Technical Evaluation Report on the Content of the U.S. Department of Energy's Yucca Mountain Repository License Application

Postclosure Volume: Repository
Safety After Permanent Closure

**Office of Nuclear Material Safety and Safeguards
Division of High-Level Waste Repository Safety**

Figure 6-1. Potential Flow Pathways in the Engineered Barrier System (SAR Figure 2.3.7-8; DOE, 2008ab)

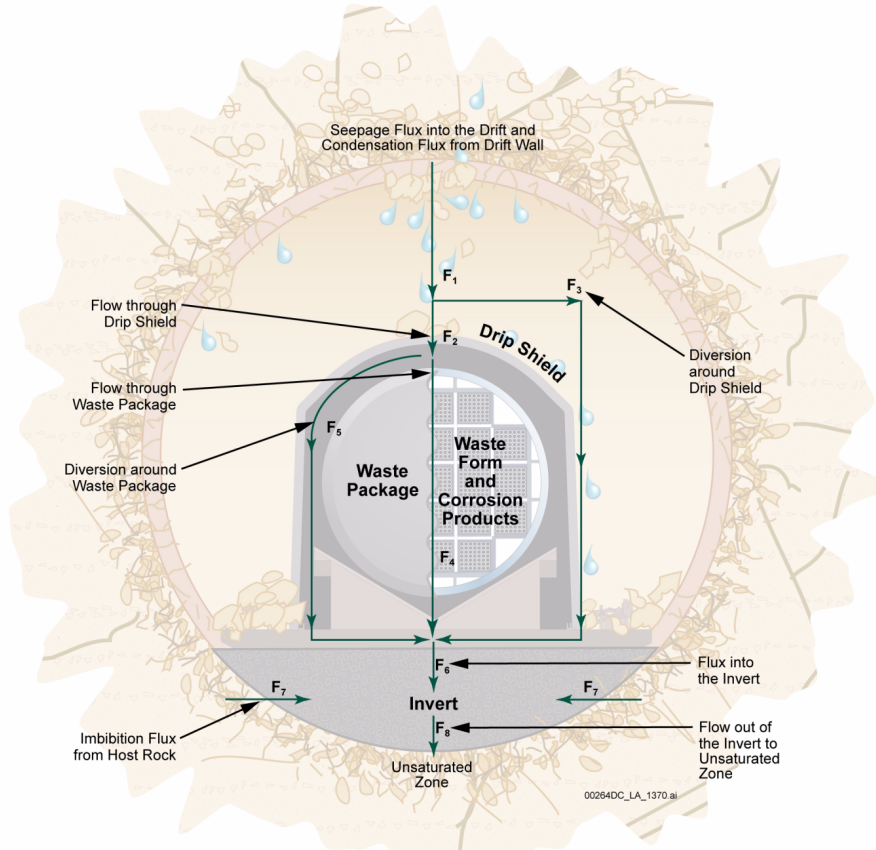
DOE described the flow pathways and flux rates (F1–F8) in the engineered barrier system flow abstraction as follows (Figure 6-1): the F1 flow path accounts for the total dripping flux from a drift wall. The total dripping flux is the sum of the seepage flux arriving at the drift wall from above and the condensed water on drift walls (TER Section 2.2.1.3.6.3.4); these are direct

inputs to the engineered barrier system flow abstraction. The F2 flow path accounts for the flux through partially failed patches of the drip shield formed by general corrosion.
